**RE: RESPONSE TO REQUEST FOR FURTHER INFORMATION FOR A DEVELOPMENT AT  
COTTBROOK, CASTLEKELLY, BOHERNABREENA, CO. DUBLIN, D24 YY42**

**SOUTH DUBLIN COUNTY COUNCIL REG. REF. 'SD22B/04,65'**

Figure 1.1: Proposed Extension as Originally Proposed (Left) and Revised RFI Scheme (Right)

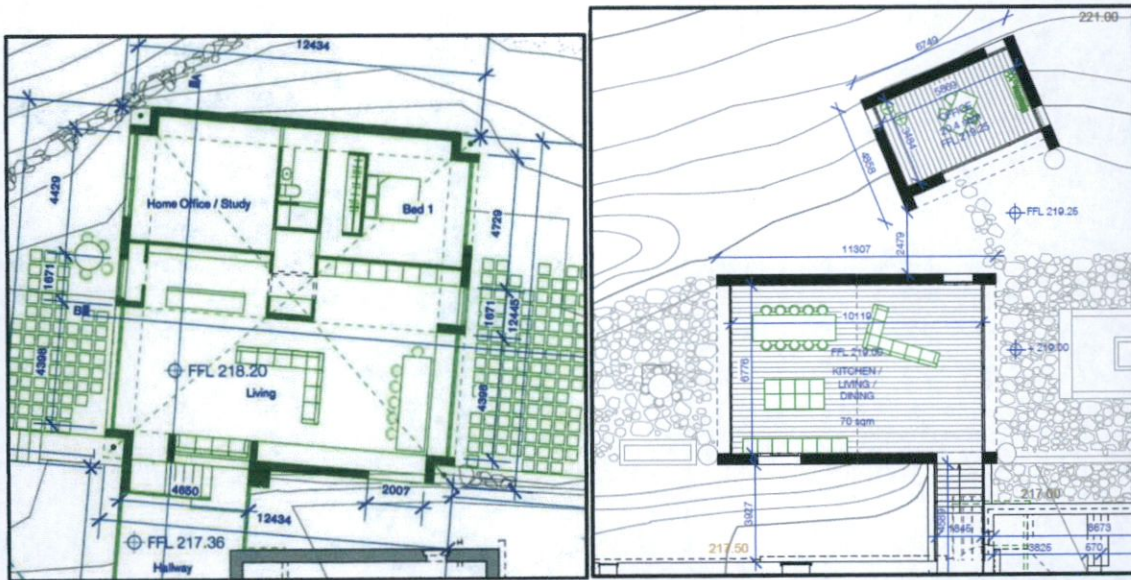
The residential extension, as originally lodged with the Planning Authority, has been modified to address matters raised in the *Request for Additional Information*. The modifications are shown on the plans and particulars submitted with the key changes summarised below for ease of information:

- The floor area of the proposed house extension has reduced by 91 sq m (from 162 sq m to 71 sq m), removing the previously proposed master bedroom and en-suite in addition to the office proposed as part of the dwelling house;

Figure 1.3: Side Elevation of the Proposed Extension Indicating the Type of Roof Originally Proposed (Top) and the Revised Type (Bottom)

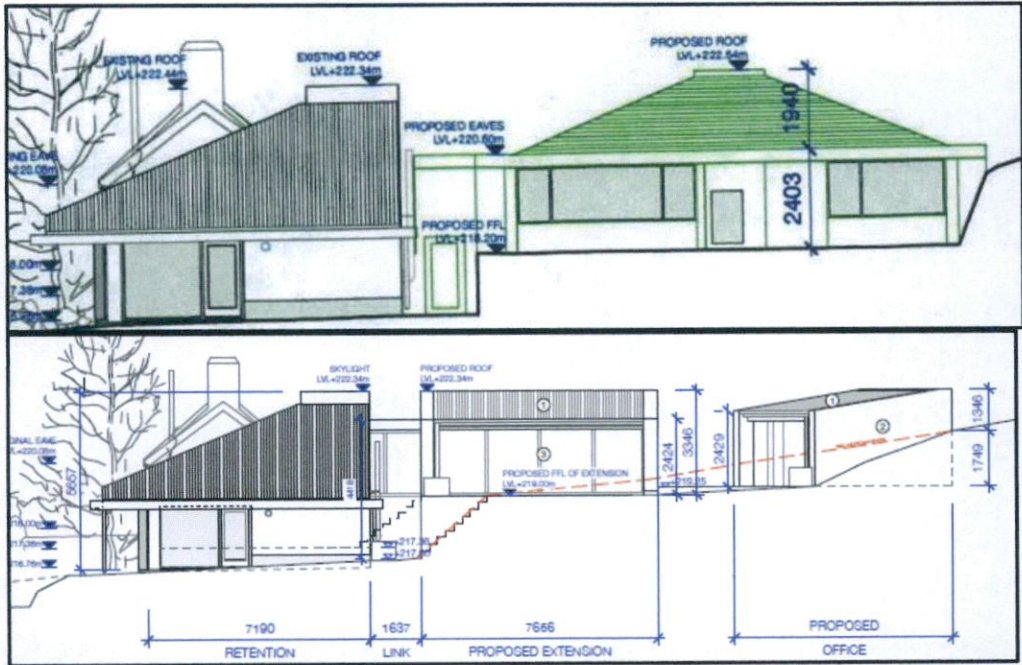
- The type of roof proposed has changed from large hipped roof to low hipped roof;

Figure 1.4: Extract from the Existing Site Plan Showing Position of Existing Home Office- Now Proposed to be Removed

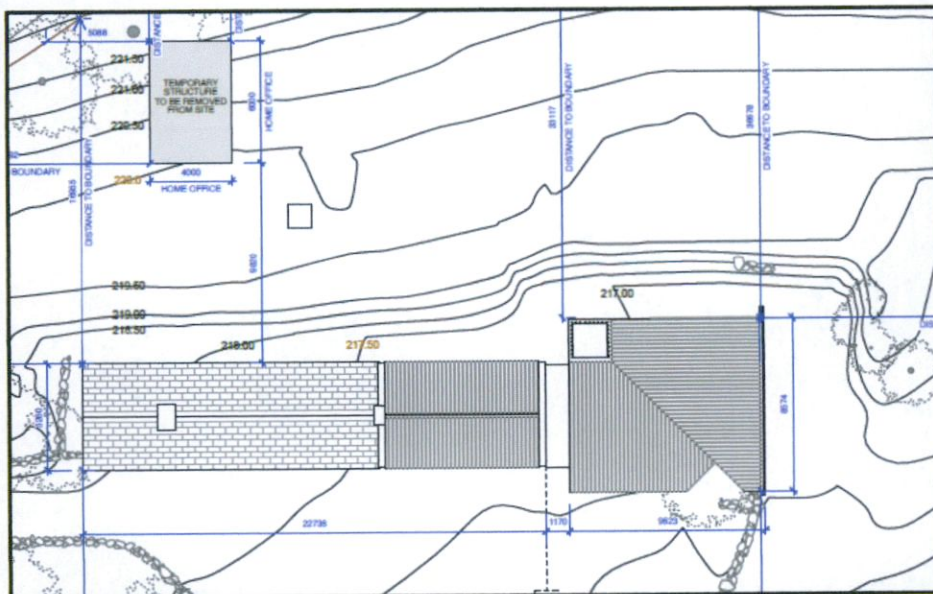
- The removal of a separate ancillary residential structure of 24 sq m that was constructed as exempted development and has been used as a home office, located to the southwest of the existing dwelling.

The single storey outbuilding that exists on site is shown on Dwg. No. 135 P 110 and is now proposed to be removed.

**Figure 2.1** Ground Floor Plan as Submitted (left) and the Updated Ground Floor Plan (right)

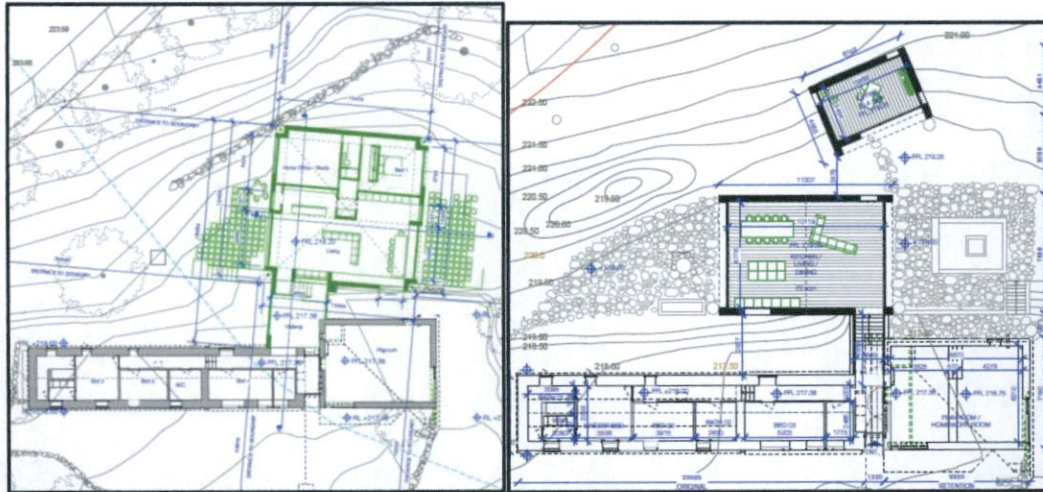
*"The site is zoned within the Bohernabreena / Glenasmole Reservoir Restricted Area, per Appendix 5 of the Development Plan. H19 Objective 2 and IE3 Objective 5 state it is an objective of the Plan 'To generally prohibit development within restricted areas identified on the Bohernabreena / Glenasmole Reservoir Restricted Areas Map contained in Appendix 5.' It is not considered that this precludes the applicant from*

*developing at the site however, given the sites sensitivity, it is considered that the development as proposed is excessive in scale. Policy H2o Objective 1 restricts the scale of extension that would be acceptable in the HA-LV and HA-DV zones to no more than 50% of the original structure. This is considered an appropriate measure against which to assess the current proposal. In this regard, the applicant is requested to revise the proposal, significantly reducing the size of the proposed extension so as not to exceed the size of the current house by more than 50%. This would result in an acceptable size of development of approximately 70 sq.m. Revised plans, elevations and sections should be submitted as relevant, amending the proposal. In revising the scheme, the applicant should have regard to the existing dwellings vernacular style and reflect this in the design of any extension. In addition, development should reflect the topography of the site, reducing the need for hard engineered solutions. The applicant should have regard to Section 12.3.5 of the Plan which states that 'Proposals should ascend the contours of the site with unique design solutions such as lower density split level housing and sloping gardens with planted boundary treatments. Where changes in ground level between buildings are unavoidable, planted banks may be utilised.'*"

In order to fully respect the policy and to comprehensively address this item of the *Request for Further Information*, the proposed house extension has been reduced in scale from a gross floor area of 162 sq m to 71 sq m, a total reduction of 91 sq m. Thus, the completed dwelling would have a gross floor area of 211 sq m if the RFI scheme is permitted.

The height of the proposed extension has been reduced by 1 m, from 4.3 m to 3.3m in order to minimise its visual impact. The revised scale of the extension is shown in the re-submitted drawings prepared by Clancy Moore Architects, and are illustrated in Figure 2.1, 2.2 and 2.3 below.

**Figure 2.6: Topographical Survey of the Subject Site Including the > 20% Slope Highlighted in Yellow.**

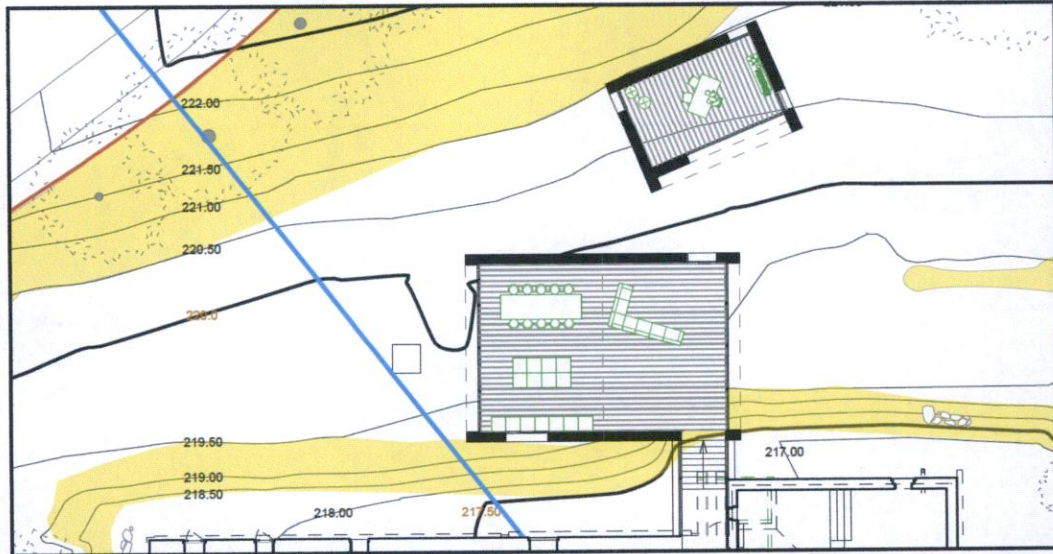
*“There are concerns about the gradient of the site and its suitability to handle additional development, given the impact of increased hard standing and the interruption of the flow of surface water runoff. Section 12.3.5 of the Development Plan states that proposals on sites with a steep and / or varying topography should be accompanied by a comprehensive site analysis (including character appraisal and movement analysis), concept proposal and design statement as described and illustrated within the Urban Design Manual – A Best Practice Guide, DEHLG (2009). Such analysis should be accompanied by comprehensive site sections and plans detailing any proposed changes in site level and demonstrating how the proposal incorporates the natural slope and drainage features of the site. The applicant has not provided this information and is requested to do so to allow a full assessment of the proposed development and its potential impacts. In compiling this information, the applicant should also undertake and submit a topographical survey of the site, to determine its suitability for development.”*

A topographical survey including the > 20% slope is illustrated in Drawing No. P 157. The FFL of the proposed extension is approximately 1-2 metres above the FFL of the existing dwelling. In this regard, the design rationale for the proposed extension was to ensure the existing dwelling is the primary built form on the subject site. To accomplish this, the proposed extension settles into the existing topography and comprises only a single storey with a low-pitched roof.

Figure 2.9: Northern Elevation of the Original Structure (Left) and the Existing Structure (Right)

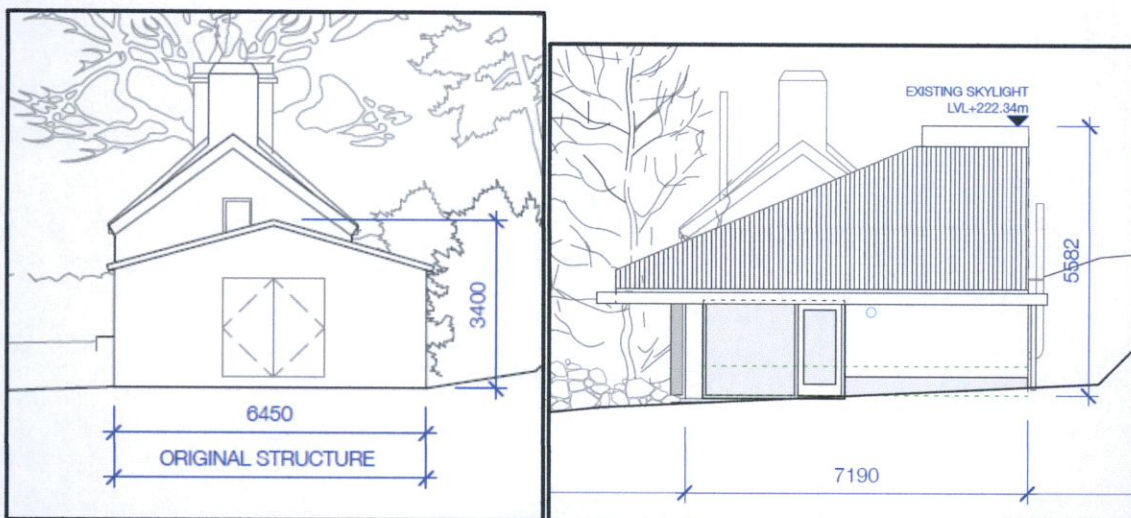
*"It is not clear from a site visit and a review of the SDCC planning record the planning status of certain elements of the existing dwelling. The applicant is requested to provide clarity in relation to any additions to the original cottage and regularise this development as necessary. In addition, from a site visit it was evident that a single storey outbuilding has been constructed at the site. This does not appear to be indicated on existing or proposed site layout plans, and the planning history of this structure is also not clear. The applicant is requested to clarify this and ensure that all existing and proposed site plans include ALL structures on site."*

The works carried out change the appearance of the structure as shown in Figure 2.8 below and increase the area of the structure by 10 sq m (within the threshold of 40 sq m that can be considered exempt), however it is likely a matter of opinion as to whether the works render part of the dwelling inconsistent with the character of the structure or not. Due to the level of subjectivity in this regard, it has been decided to include the retention of the works as part of the subject application.

**Figure 2.11: Topographical Survey Including the >20% Slope and 100m From Streams**

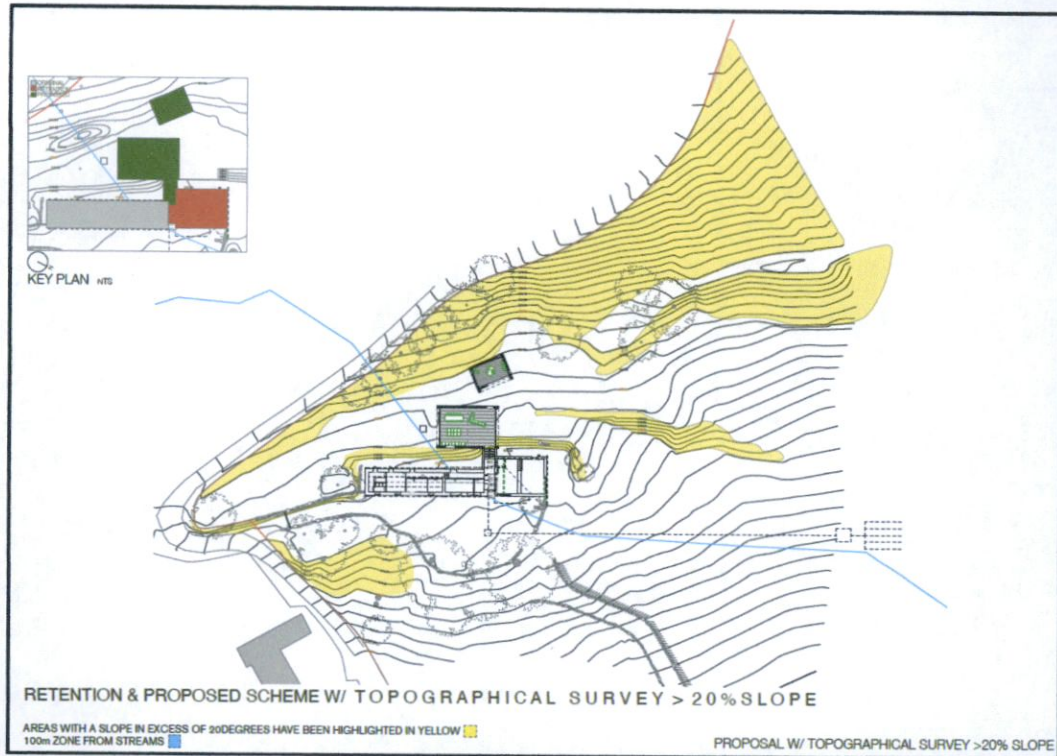
*"It appears from a review of Appendix 5 of the Development Plan that the area for which development is proposed overlaps with both the 100m zone from streams and slope greater than 20% layers of the Map showing the Restricted Areas for Development Glenasmole and Bohernabreena. The applicant has indicated these areas on layout plans however, there is a discrepancy in the areas shown on the applicants submission, and the areas shown on the map contained at Appendix 5. The applicant is requested to clarify this item, updating maps as necessary or confirming how conclusions were reached on site about where these layers have been shown."*

In response to Item No. 6 of the *Request for Additional Information*, a Topographical Survey (Drawing no.157) has been submitted alongside this Cover Letter, which clearly indicates the 100m zone from streams and slopes greater than 20% (Figure 2.11).

As demonstrated by Figure 2.11 above, the proposed works are located outside of both the 100m zone from streams and also the area subject to slopes greater than 20%.
